RE: **Final Site Plan Review (SPA 23-0001)** for the construction of a 22,360-square foot multi-tenant commercial building, with associated parking and site improvements. Site location is 7749 E M-36; TID 15-25-200-068.

To: Planning Commissioners
From: Amy Steffens, AICP
Planning and Zoning Director
Date: June 21, 2023

Project address and Description: **Site Plan Review (SPA 23-0001)** for the construction of a 22,360 square-foot multi-tenant commercial building, with associated parking and site improvements. Site location 7749 E M-36; TID 15-25-200-068.

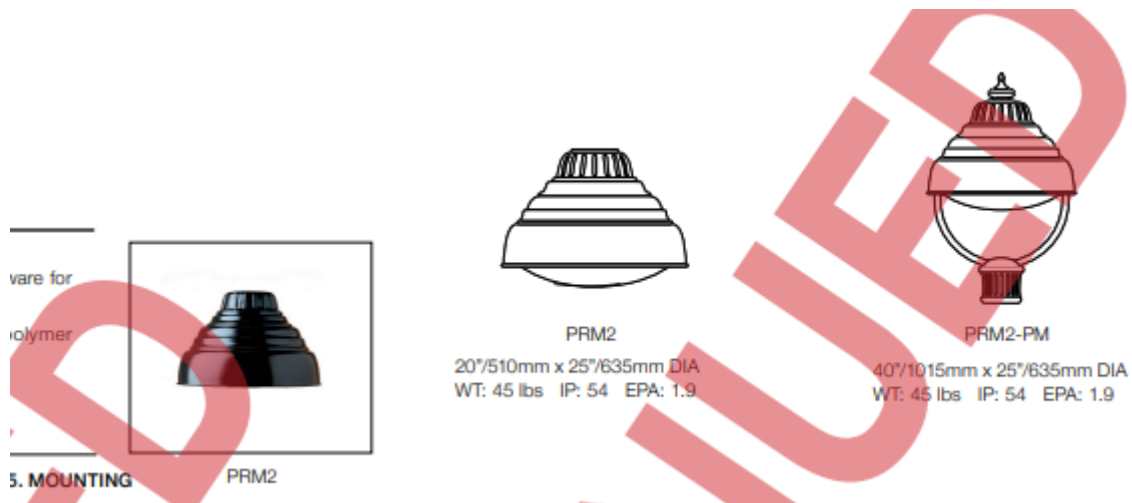
1. Cross access easement for the pedestrian pathway shall be submitted for township attorney approval and recorded prior to issuance of a land use permit for any site improvements.
An easement is indicated on the site plan. Staff will work with the applicant and township attorney to formalize the easement for recording prior to issuance of land use permits.
2. A floating easement to allow cross-access across subject site from adjacent properties should the subject site be redeveloped shall be submitted for township attorney approval and recorded prior to issuance of a land use permit for any site improvements.

An easement is indicated on the site plan. Staff will work with the applicant and township attorney to formalize the easement for recording prior to issuance of land use permits.

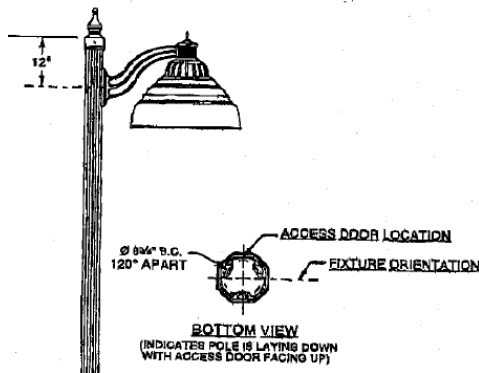
1. **Exterior lighting shall be fully shielded and directed downward toward the Earth's surface, away from residential uses, roads, glass, water or other reflective materials which would create excessive off-site glare or incident rays.**

The lighting plan provided is adequate to determine the conformance to the zoning ordinance requirements. However, staff would suggest that the exterior light style does not match the Village Center lighting style that has been installed in various locations throughout the Village Center, most recently at the senior living facility on the south side of M-36 (below).

Staff Suggestion Condition: Applicant shall propose an exterior light that is similar to the suggested Village Center lighting and shall re-submit a photometric plan prior to issuance of a land use permit that is specific to the approved lighting style.

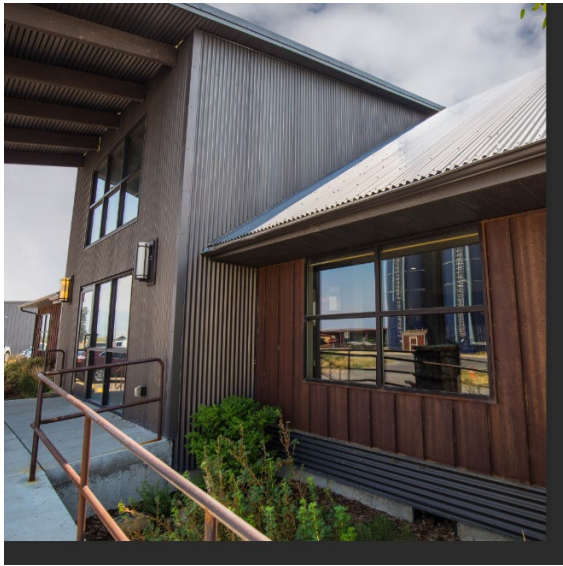
Section 36-73(7) specifies that “For any side of a principal building facing a public or private street, at least 50 percent of the facade shall be constructed of, or covered with, the following materials: brick; fluted or scored concrete block; cut stone, vinyl siding; vinyl siding; glass; or other materials similar to the above as determined by the Planning Commission.” The metal siding would need to be approved by the Commission as an acceptable substitute to the noted materials.

Additionally, building walls over 100 feet in length shall be broken up with a combination of the following: varying building lines, windows, architectural accents, and trees. The only windows on the 292-foot long east elevation are the windows on the tenant space entry doors.

The proposed elevations are uninspired and wholly inappropriate for a commercial structure along a gateway into Hamburg Township that is zoned Village Center. There are multiple ways to add interest to a metal-sided rectangular building. Height and depth articulations, additional windows, and a mix of exterior finishes would break up the expansive east elevation and add aesthetic interest to the south elevation. Staff offers the images below as examples of architectural details that could be used on the proposed building. The Commission should also consider requiring additional finishes on the south and north elevations.

TREE PROTECTION DETAIL

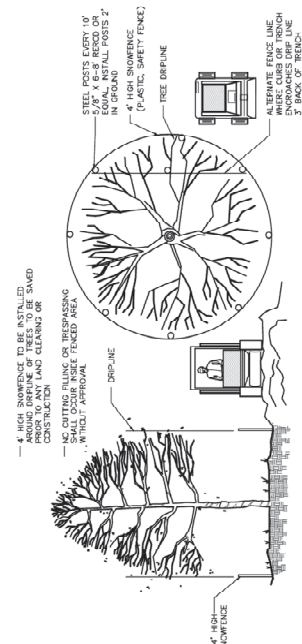
9. Tree preservation location and details shall be delineated on the final site plan.
Completed; see sheet LA1.1
10. A change of use permit shall be issued for every occupant of the structure. At the time of permit application, a parking count shall be provided by the property owner indicating the available parking for each use.

Staff analysis: Existing plant material to be saved is not noted on the site plan; tree protection details are included in the site plan.

Staff suggested condition: Tree preservation details shall be delineated on the final site plan.
